**U.S. DEPARTMENT OF ENERGY  
BROOKHAVEN NATIONAL LABORATORY  
CERCLIS NUMBER NY7890008975**

**FINAL AREA OF CONCERN 9  
BROOKHAVEN GRAPHITE RESEARCH REACTOR  
EXPLANATION OF SIGNIFICANT DIFFERENCES**

**April 23, 2012**

**Section View of Biological Shield During Removal Activities  
(Typical for North, West & South Walls - Similar for East Wall)**

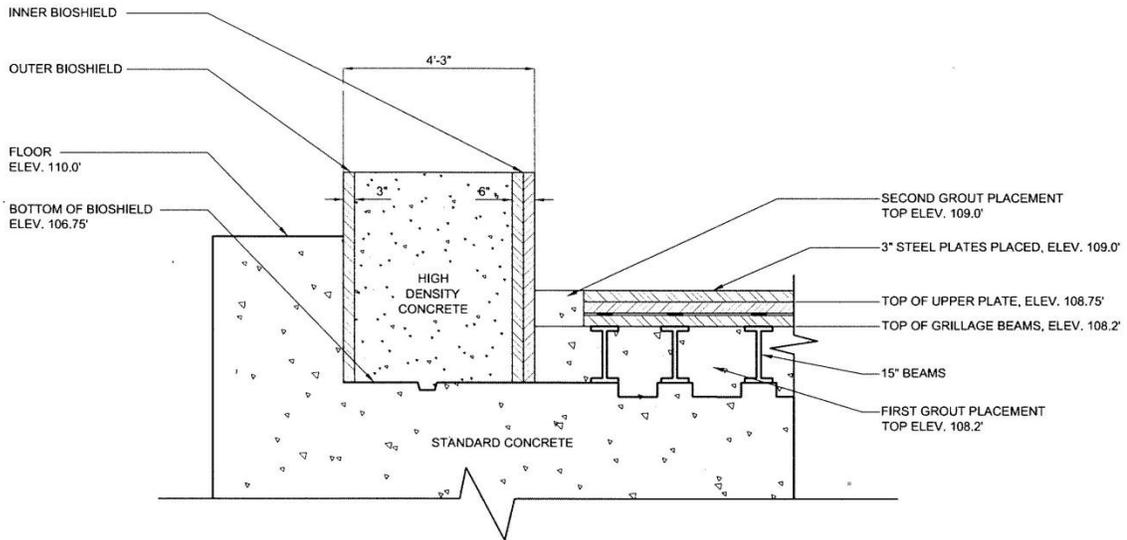
During initial phases of the biological shield removal project, a remote-operated, rail-mounted excavator with a hydraulic breaker hammer was utilized to break the concrete on the roof and sidewalls. Once the roof had been removed, and removal of the sidewalls was in progress, it became evident that this excavator/hammer unit lacked sufficient force to break the high-density concrete effectively enough to support the project schedule. The decision was made to deploy a larger excavator/hammer unit which would be capable of breaking the concrete in the walls at a higher rate. Once the new unit was selected, it was determined the building floor as well as the floor area within the footprint of the biological shield required reinforcement to support the machine, which weighed over 35 tons. To accomplish this, the void areas beneath the Building 701 high bay area outside of the biological shield footprint were filled with cementitious grout, and steel plates were placed atop this floor surface to evenly spread the load of the new excavator/hammer unit. To strengthen the floor area within the

biological shield footprint, the north and south outlet air plenums were filled with reinforced concrete. This configuration not only provided a solid, void-free surface on which to operate the new excavator, it provided additional shielding which allowed workers (including the excavator operator) to enter the interior of the biological shield for the first time in the project to perform tasks that had previously been inefficiently accomplished by remote means.

**Section View of Proposed End State  
(Typical for North, West & South Walls)**

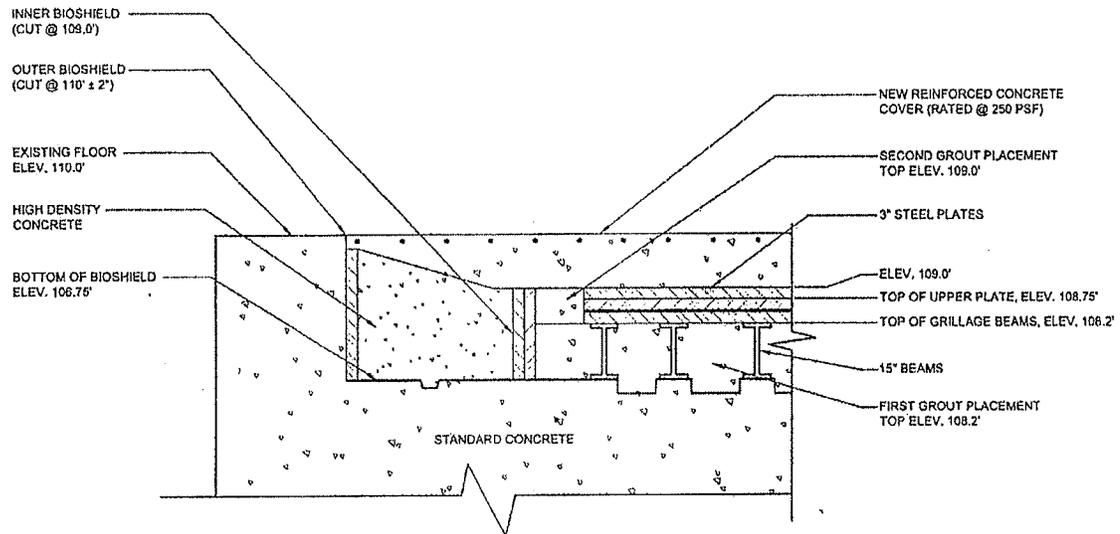
DOE proposes a completed end state which is different than that described in the Selected Remedy. Removal of the biological shield inner steel wall and concrete structure will take place at least to the existing Building 701 floor level. This change would leave approximately 650,000 lbs of concrete (approximately 8.8% of the biological shield concrete by weight) and 80,000 lbs of activated steel (approximately 4.0% by weight) in the foundation of the walls, with a total residual activity of approximately 1.1 Curies. In addition, one of the two remaining steel bed plates that supported graphite pile and was planned to be removed will remain in place containing approximately 9.8 Curies. This remaining activity is additional to the amount specified in ROD (2005) for the end state of selected remedy. Approximately 80 – 90% of this additional activity is attributed to Ni-63 decay with the remainder due to the decay of Am-241, Co-60, Fe-55 and other radionuclides. The outer steel walls, which are free of radiological activation, will also be removed to the existing floor level, leaving the foundation below the floor. The portion of the biological shield foundation remaining below the building floor will be protected beneath a reinforced concrete cover. The steel plates that were placed over

the pile bedplates and cementitious grout installed during the removal activities will also remain in place beneath the reinforced concrete cover. This will provide for a structurally stable long-term configuration, with no void spaces, no pathway to groundwater for radioactive contaminants, and radiological dose rates less than 0.1 milliRem per hour (mR/hr). This change in end state does not affect the planned long-term surveillance and maintenance activities for Building 701.
